SUBJECT: Forwards response to request for addl info re control room  
 habitability evaluation. Attachment A to ltr describes 900919  
 event & design mods planned.

Subject: Duane Arnold Energy Center  
Docket No: 50-331  
Op. License No: DPR-49  
Response to Request for Additional  
Information Regarding DAEC's Control  
Room Habitability Evaluation  
Reference: Letter, C. Shiraki (NRC) to L. Liu (IELP)  
dated August 2, 1991  
File: A-107a

## RESPONSE TO REQUEST FOR ADDITIONAL INFORMATION

CONTROL BUILDING VENTILATION  
(Simplified)

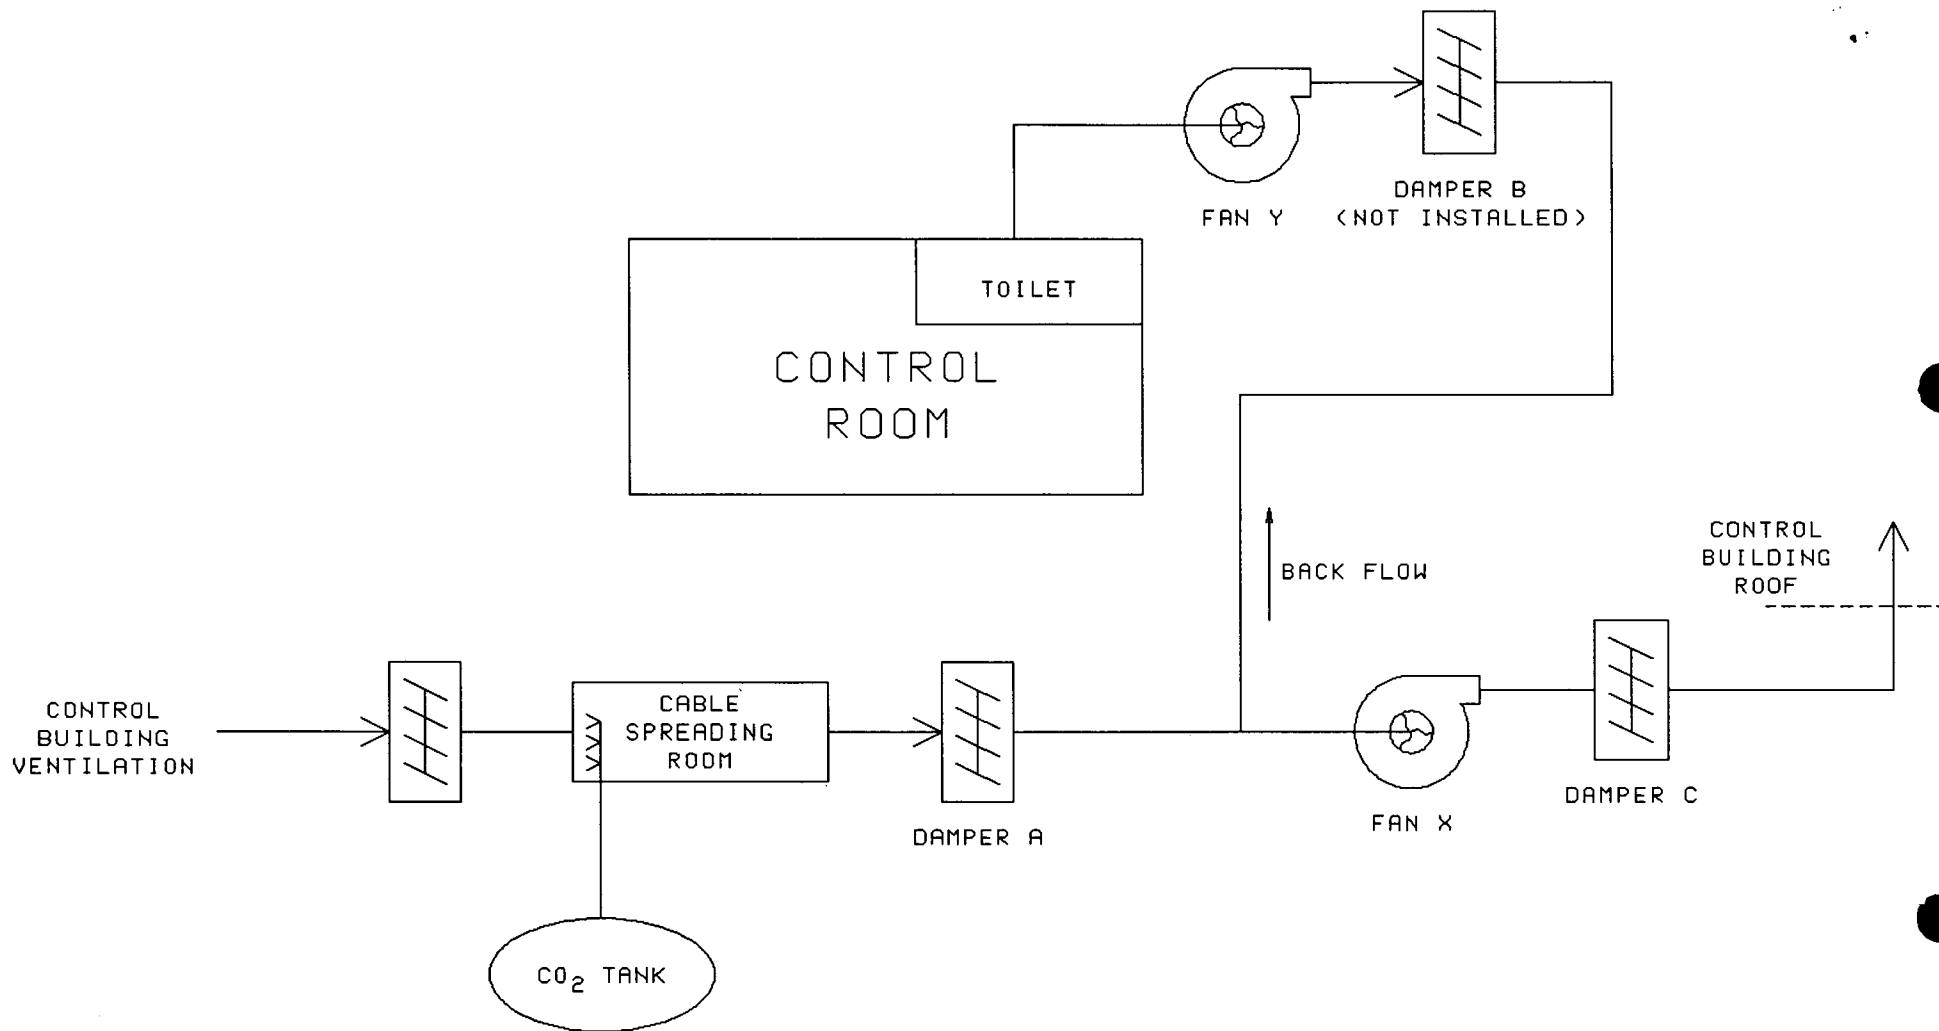
The modifications to the ventilation system were completed in May 1974. Additional fire dampers were installed in the Cable Spreading Room and the CO<sub>2</sub>-actuated logic on the room exhaust damper (see Damper A Attachment B) was replaced with 360 degree F fusible links. The exhaust damper would then remain open until the fusible links sensed an actual fire (360 degrees F) thereby maximizing the availability of a vent path to prevent overpressurization of the Cable Spreading Room.

It was during the investigation of the September 19, 1990, event that we identified that the backdraft damper (see Damper B) which was intended to prevent air from backflowing into the Control Room from the Cable Spreading Room was never installed. Design documentation has always reflected a damper in the line and consequently, its presence was assumed in the later habitability evaluations. Despite vigorous efforts, we are unable to explain its absence. Additionally, we determined that upon CARDOX actuation, the room exhaust fan (see Fan X) secures and the fan's discharge damper (see Damper C) closes, effectively blocking the intended vent path. Therefore, the 1974 ventilation modifications were ineffective in that a CARDOX initiation can still pressurize the Cable Spreading Room and, without the backdraft damper, CO<sub>2</sub> can backflow into the Control Room.

Design modifications have been initiated which will address the backflow through the control room exhaust fan (see Fan Y) and ensure the proper venting of the Cable Spreading Room in the event of a CARDOX initiation. These design changes will be complete prior to shutdown for the Cycle 11 refueling outage. Additionally, post-modification testing will be performed during the Cycle 11 outage to verify the effectiveness of these modifications. Upon successful completion of this testing, the Control Room habitability evaluation described in UFSAR Section 6.4 will be revised to reflect the analysis of and corrective actions resulting from the September 19, 1990 event.
